**SUBJECT: reserve parachute pocket could separate itself
from the airbag base**

Date : 20/07/2018

Document N° : SUPAIR_2018/07_002

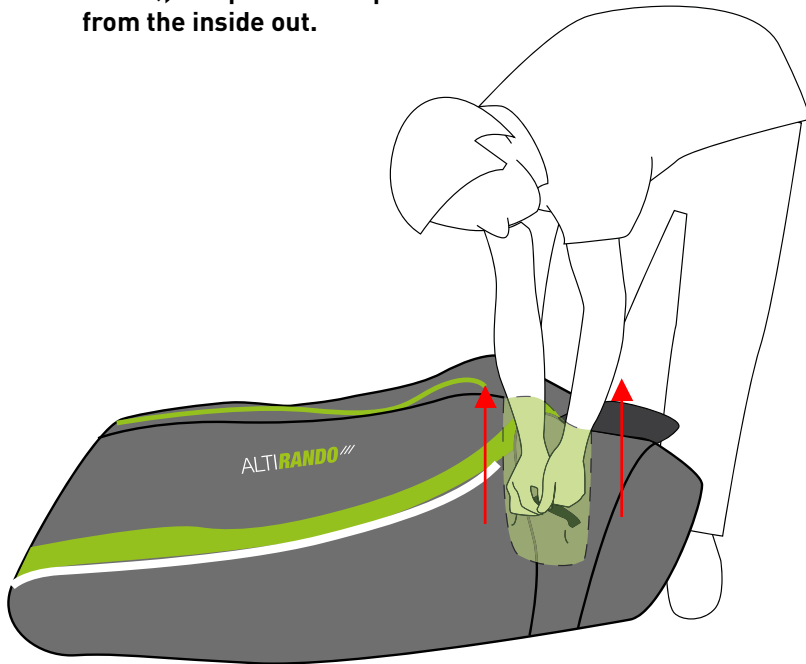
Open the pocket, take the parachute out (if there is one inside), and pull the the pocket from the inside out.

1st possibility

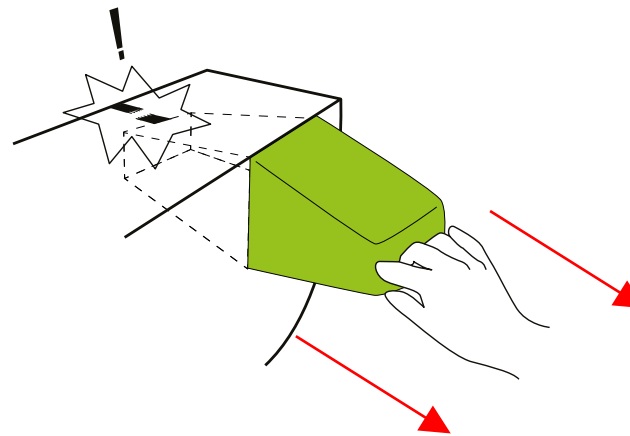
If the pocket fully unfolds toward the outside (similar to a pulled sock): You need send us the harness back for repair.
